Ref: Phase 2 Liberty Square Public Realm Scheme

Please accept this submission in respect of the above-referenced planning application for the proposed Phase 2 Liberty Square Public Realm Scheme works in Thurles, Co. Tipperary. TFI Local Link Tipperary has reviewed the plans and particulars submitted with the application and have the following observations;

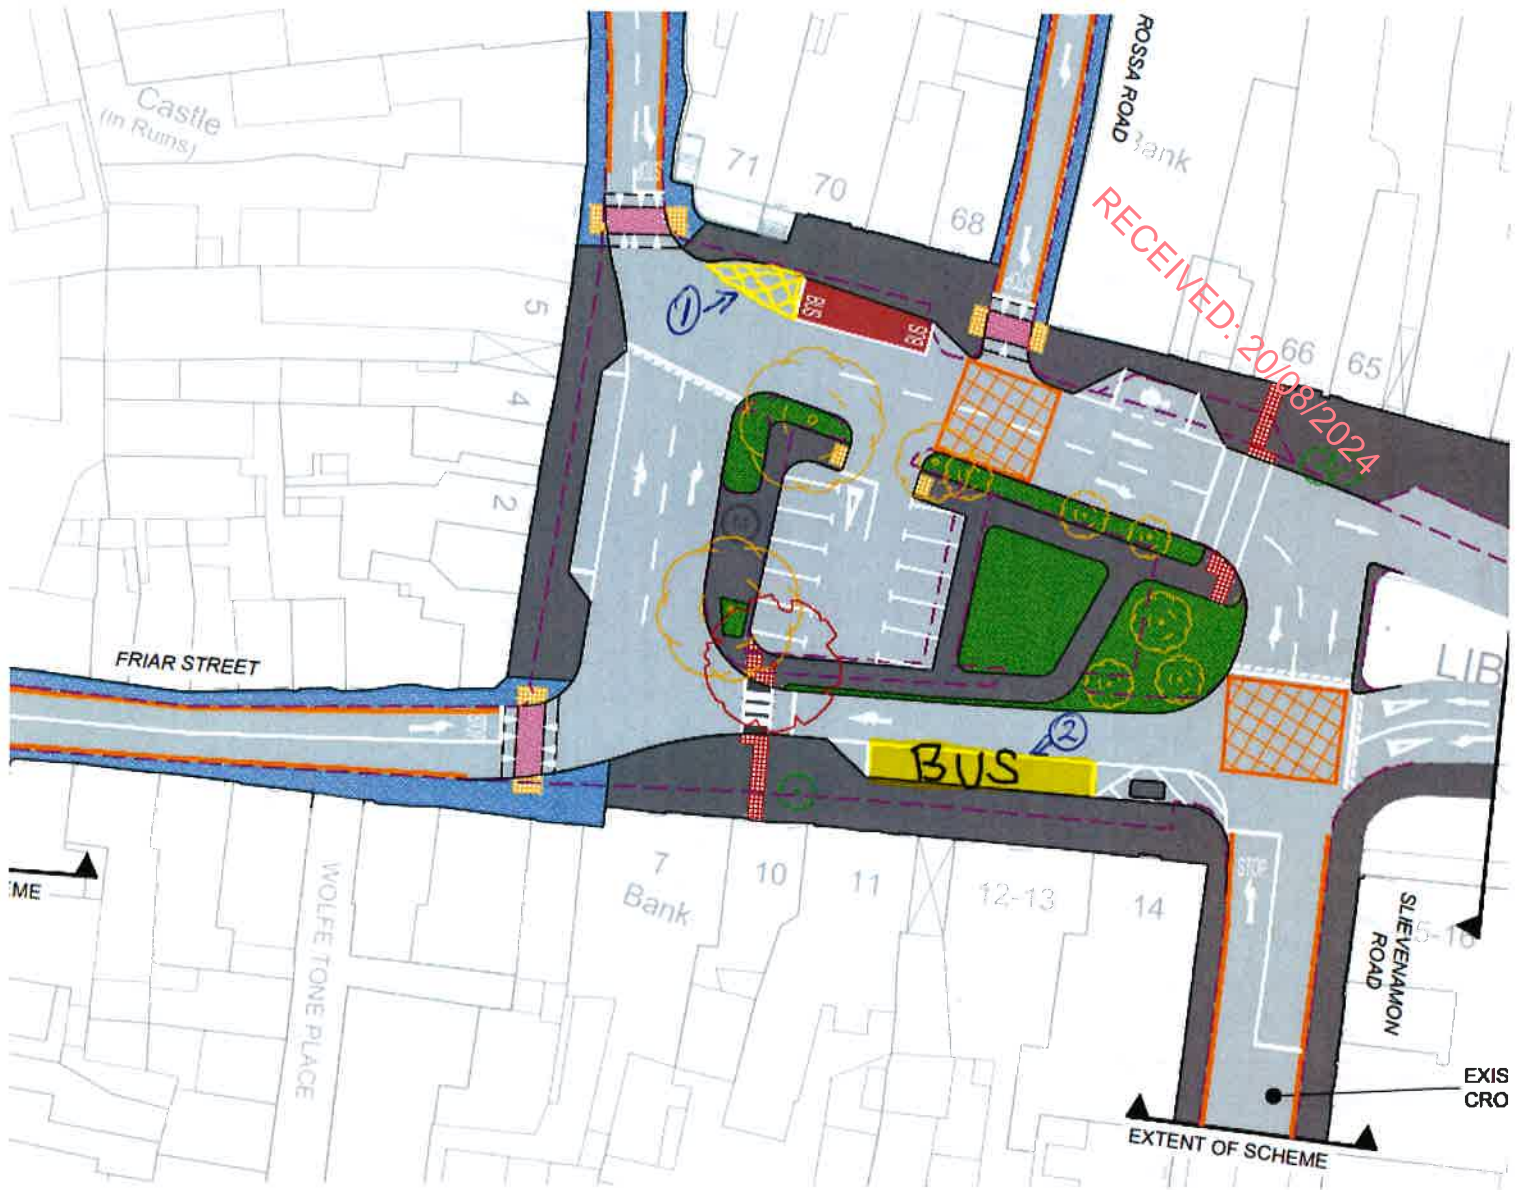
1. Bus Stop Location on Liberty Square on Mocklers Chemist side.
There are no road markings to prevent cars/other vehicles from parking between the Parnell Street Junction and the Bus stop bay. Should vehicles park in this location then the Buses will not be able to pull in sufficiently off lane and will ultimately cause disruption.
Please add road markings to prevent cars/other vehicles parking in this area.
See attached edited drawing

2. Consider adding an additional Bus stop Location on Liberty Square to be perhaps positioned at the Supermacs side of the Square. This would be helpful for two reasons.

- a. The Mocklers Chemist Bus stop bay size is only sufficient for one bus to be stopped at any one time. There are multiple services stopping in the Square, with more identified to come on stream over the next number of years under the National Transport Authority's Connecting Ireland Project.

- b. Buses (particularly for services that do not terminate or commence in Liberty Square could when arriving into the Square from the Slievenamon road (N62) and from the Dublin Road (N75) can drop passengers at the proposed indicated stop (Supermacs side) without having to circulate 360° around the square. This would alleviate congestion and disruption.
See attached edited drawing.
